SERVICE BULLETIN ML 0015

Date : 03 March, 2000
Game : Timebuster
Subject : Chaser Light Problems

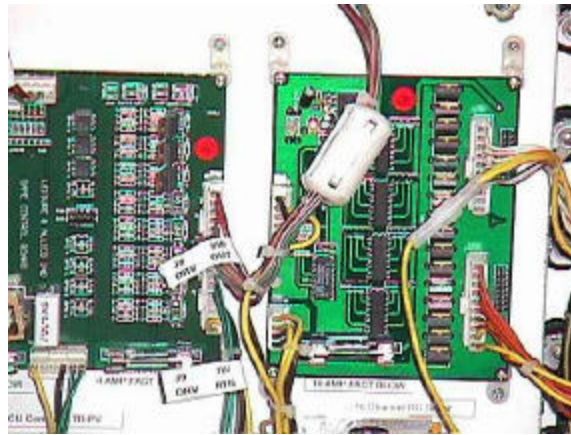
Problem : Chaser Lights have more then one set of lamps chasing around the display or lamps are flashing on or off at odd times.

Solution : Electrical noise is entering the lamp controller lines. Use a "Split" type ferrite filter (See Photo) and place it as close as possible to J8 on the CPU PCB (See Photo)
